Re:	Department's Response to Petition from Lot Owners in the Vintage Grove Subdivision.
Location:	Northwest quadrant of the Ridge Road and Old State Road intersection
Zoning:	R1-A 22,000 square foot Residence District, with a Planned Residential Development Overlay District (PRD)
Ward:	Seven

Re: Vintage Grove Subdivision – Closeout

Ref: Vintage Grove Subdivision

VINTAGE GROVE
Lot 7-11
615 OLD STATE ROAD, WILDWOOD, MO 63033
COVER SHEET

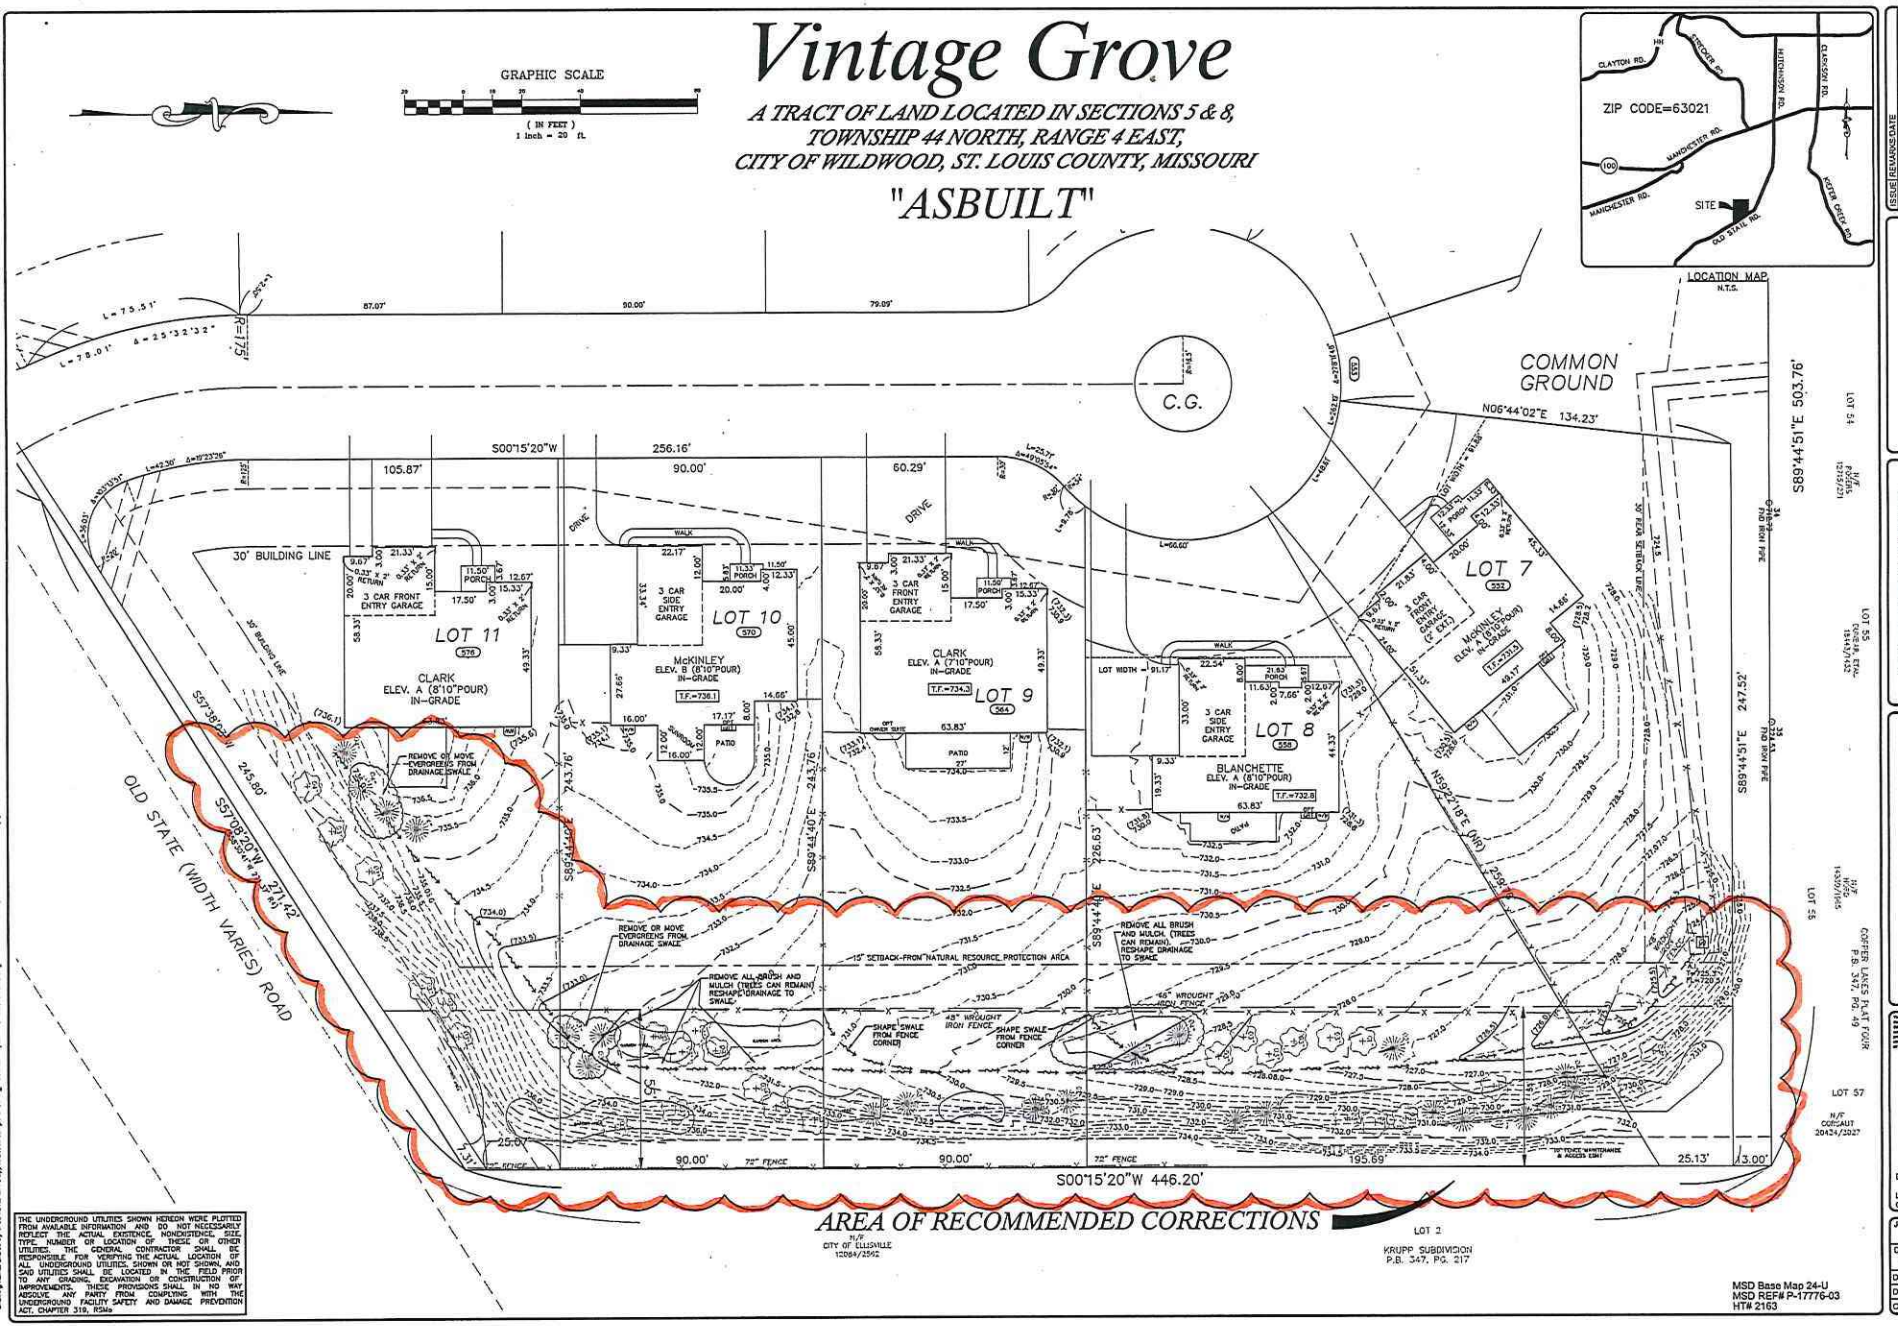
The Sterling Company has prepared an "As-built" drawing of the existing conditions and recommended corrections thereof that should be addressed to allow the site to perform as designed.

1. Remove or relocate 2 existing evergreens near the back patio of Lot 11 which are currently blocking the existing drainage swale.

2. Reshape swale near the rear of Lot 11 and the Natural Resource Protection Area (NRPA) as noted on the provided plan.

3. Remove or relocate 3 evergreens at the rear of Lot 10 in the NRPA as noted on the provided plan.

4. Remove all small brush, plants and mulch in the NRPA at the rear of Lots 8, 9 and 10 between the west fence and the designated swale of the NRPA to allow for unobstructed flow into and through the NRPA.

5. Shape swale from the existing fence corners of Lots 8/9 and 9/10 to the main swale in the NRPA as shown on the provided plan to enhance drainage of the said properties.

6. Reshape swale from the sill of the area inlet located at the rear of Lot 7 up to the North side of Lot 8 as shown on the provided plan to allow proper drainage of the subject properties and the NRPA.

DRAWN BY:	VLW	MSD P# -	17776-03
CHECKED BY:	JAH	DATE:	7/24/14
JOB NO.:	13-08-294	VINTAGE GROVE RECORD PLAT

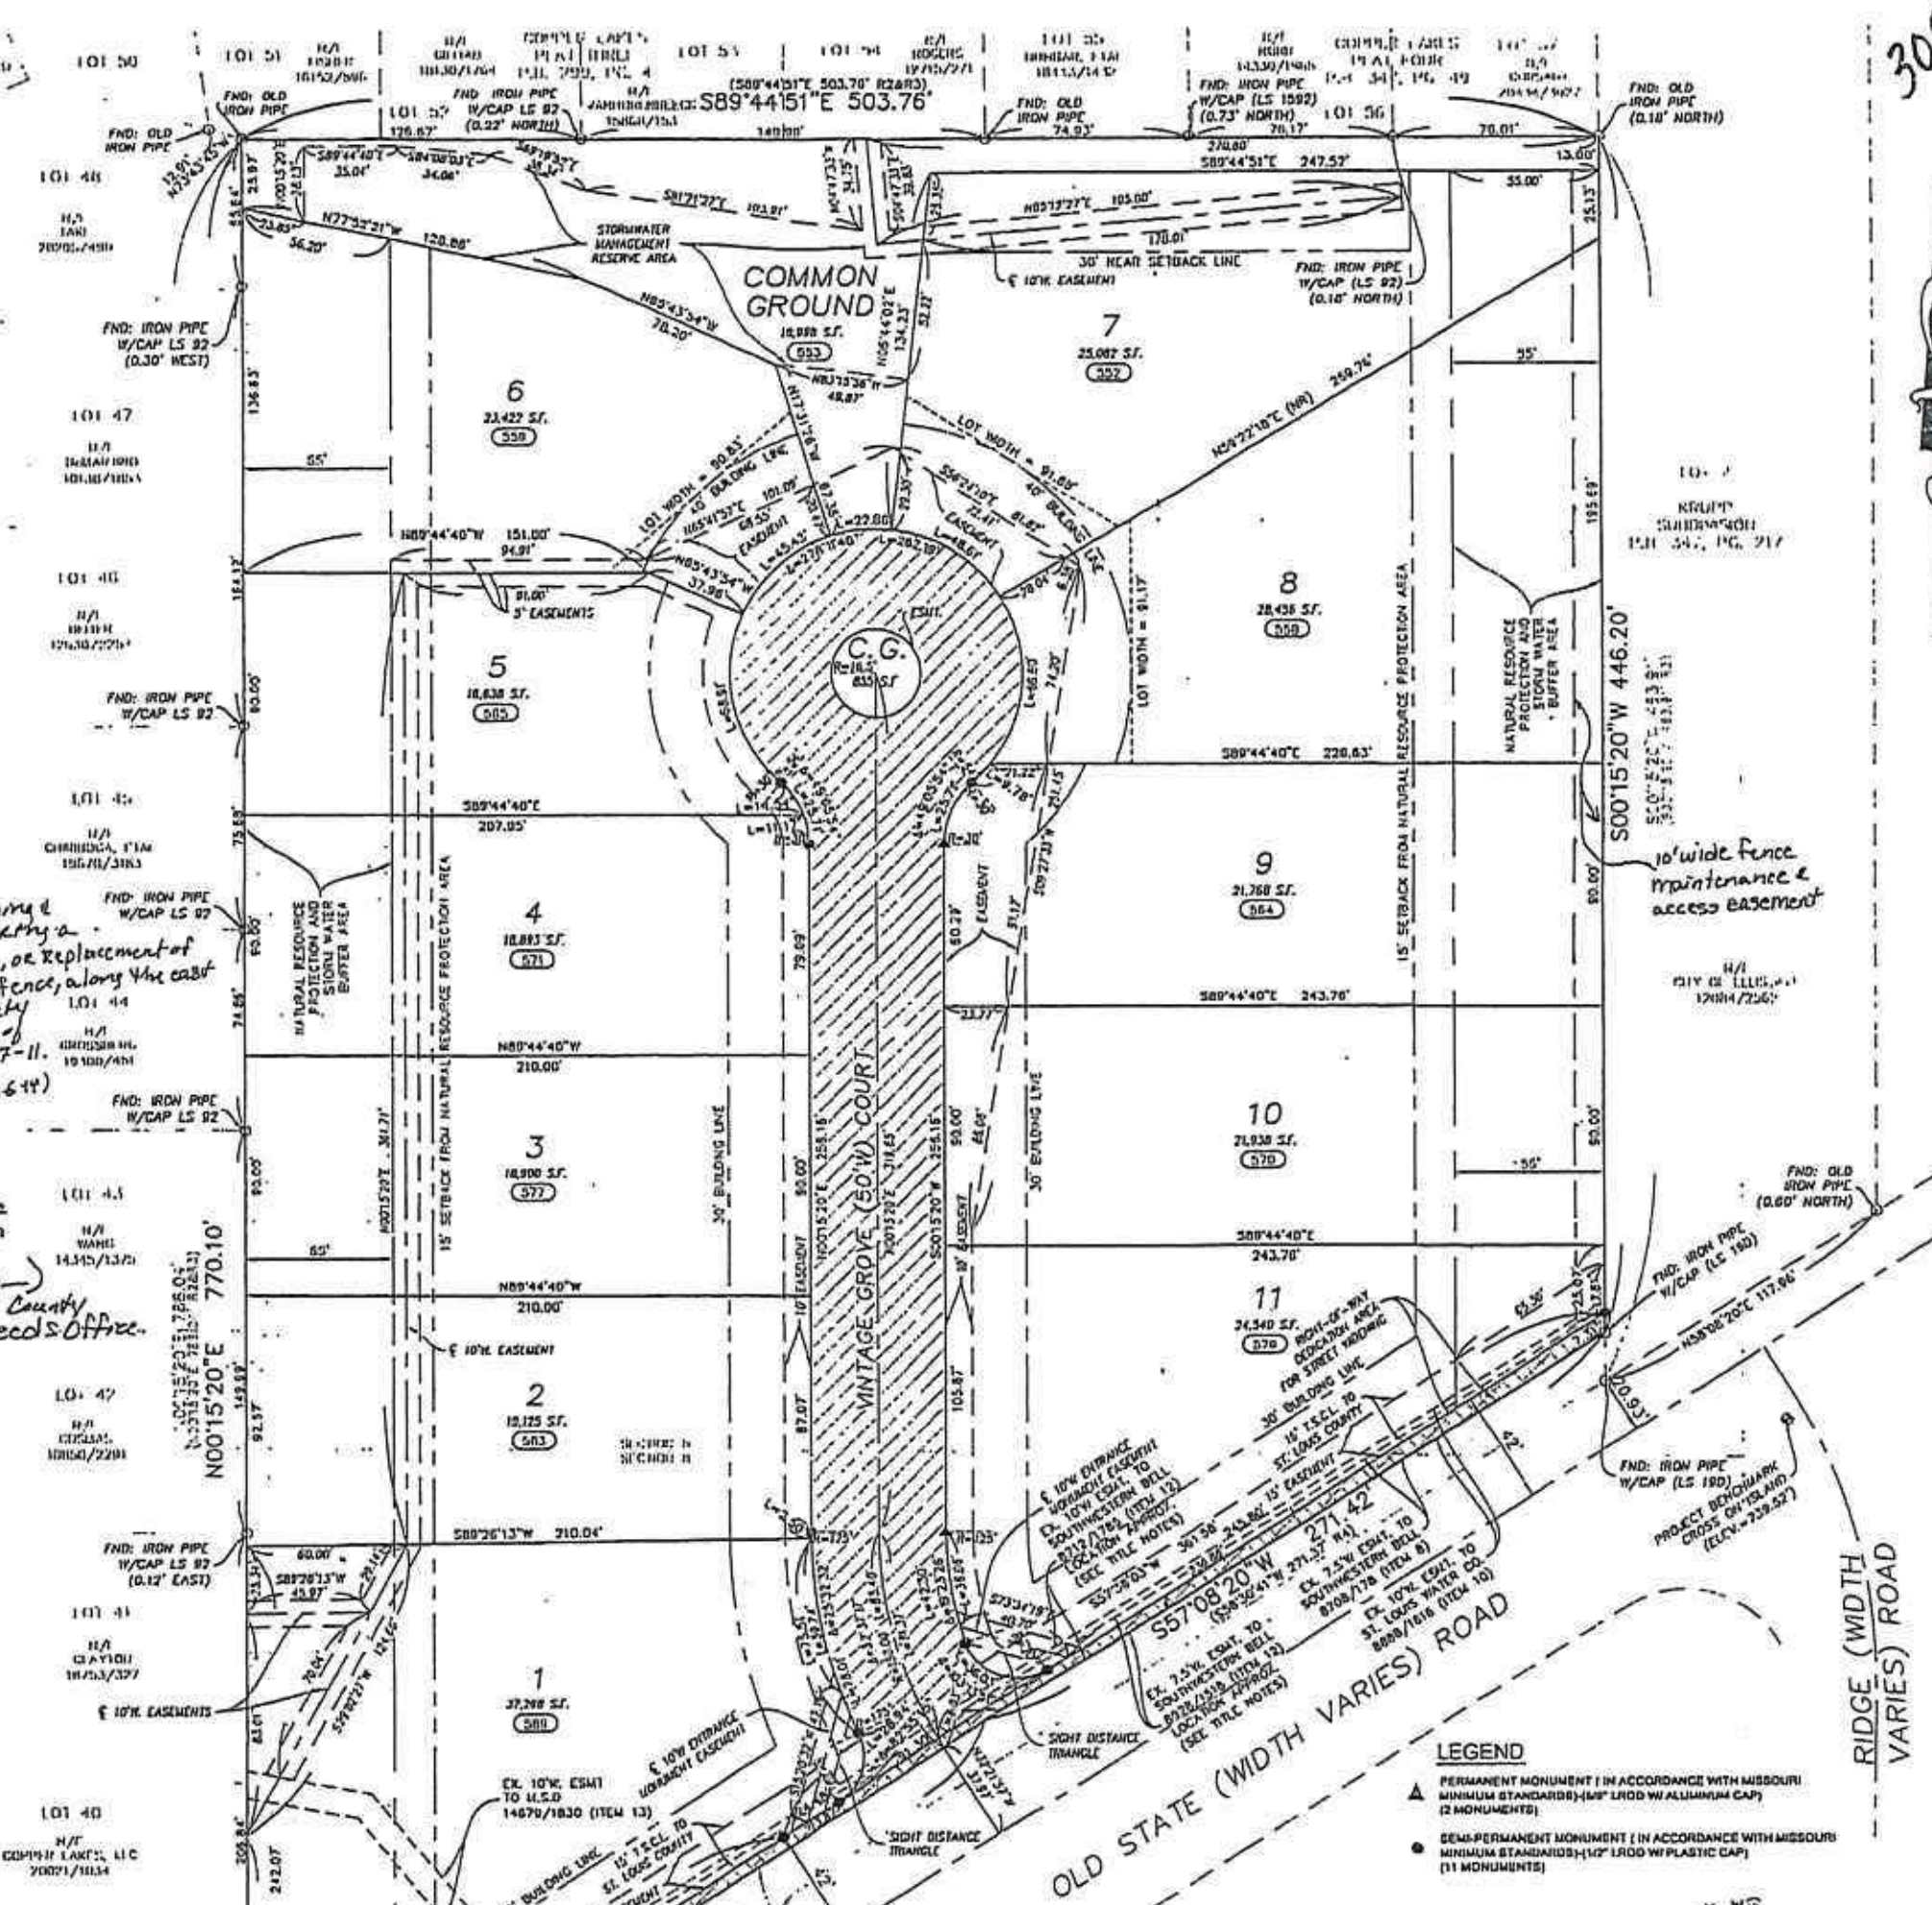
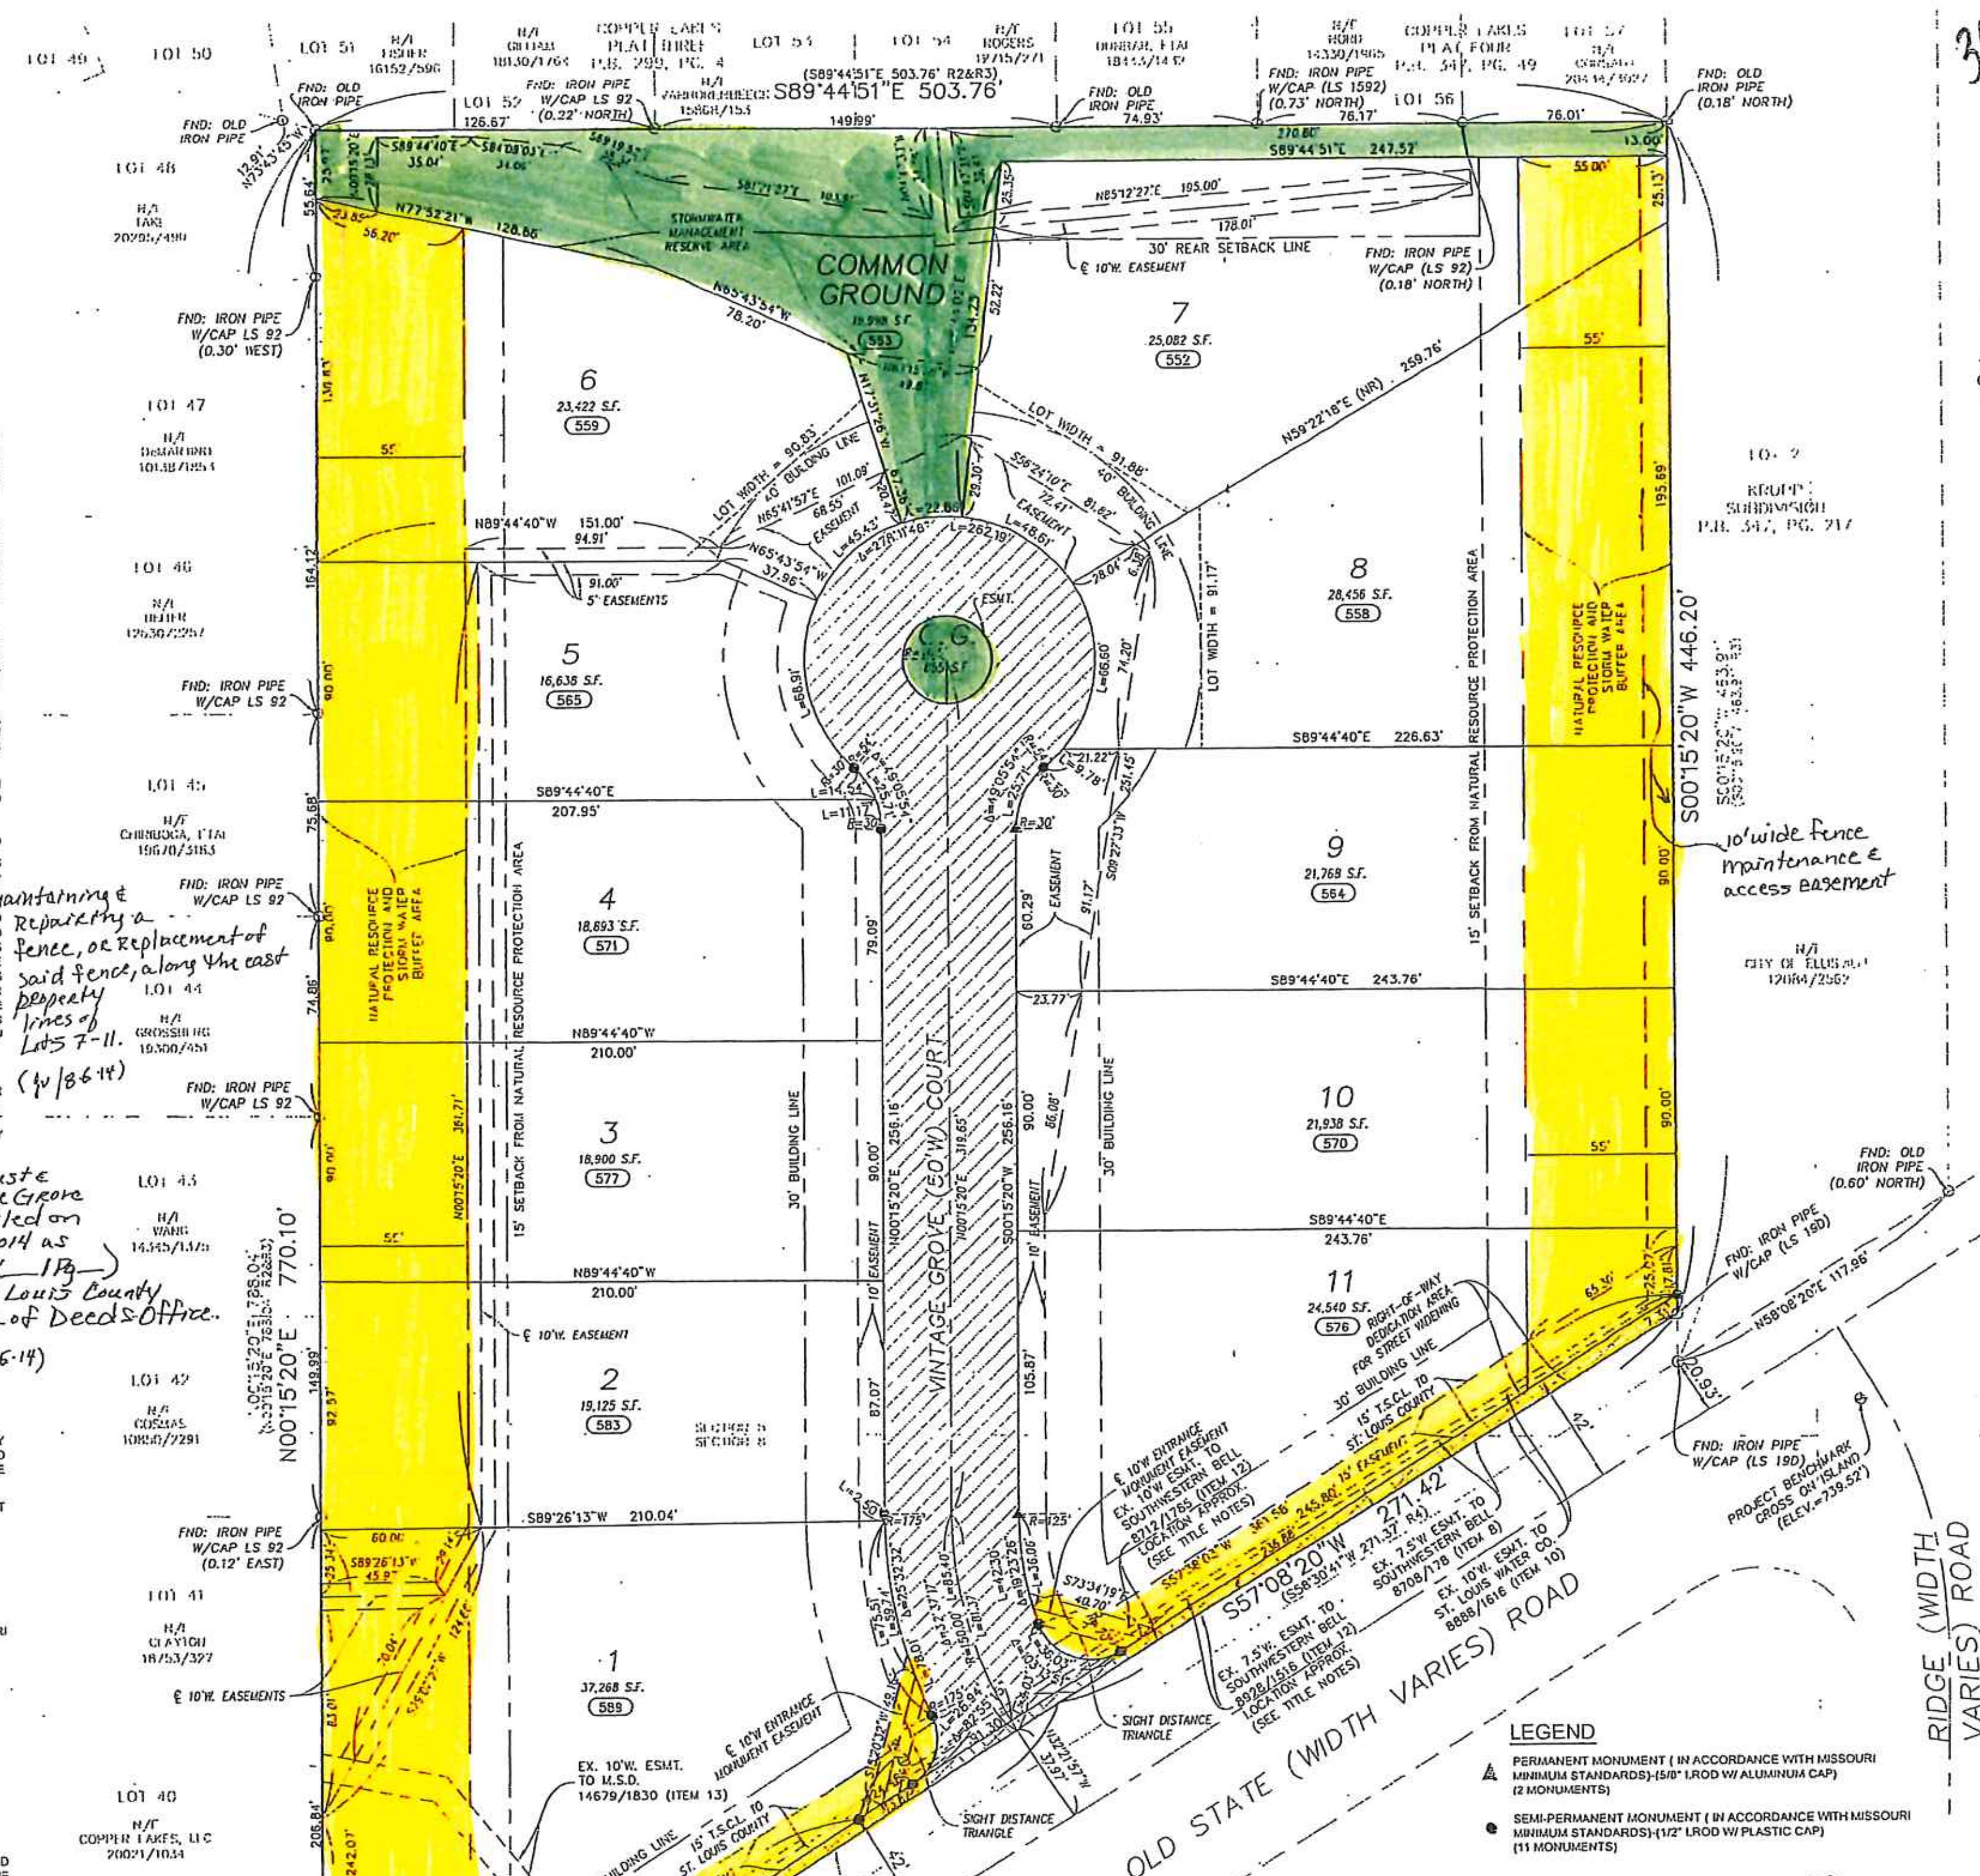
4. The review of the current drainage conditions in the rear of Lots 6 through 11. The homeowners noted that drainage behind their respective lots is poor and includes some of their own rear yard locations. This review needs to identify the current causes of these drainage problems and how to correct them. Once an agreement is reached on the corrections, work can then proceed under the supervision of the City.
5. The Department has also provided a list of other considerations for repair and/or placement, whichever is applicable. This list includes a number of items relating to individual lots, as shown upon the attached Record Plat:

F. Plant additional shrubs in common element area by Lot 1, per plan

L. Buffer Area - Remove leaning tree

M. Buffer Area - Remove dead tree trunk (near leaning tree)

N. Buffer Area - Add three (3) new trees (spruce, oak, and white pine) to replace removed dead trees

O. Buffer Area - Remove dead tree in northwest corner

P. Buffer Area - Remove and replace two (2) dying spruces by storm drain

Q. Buffer Area - Remove two (2) dead trees north of hill
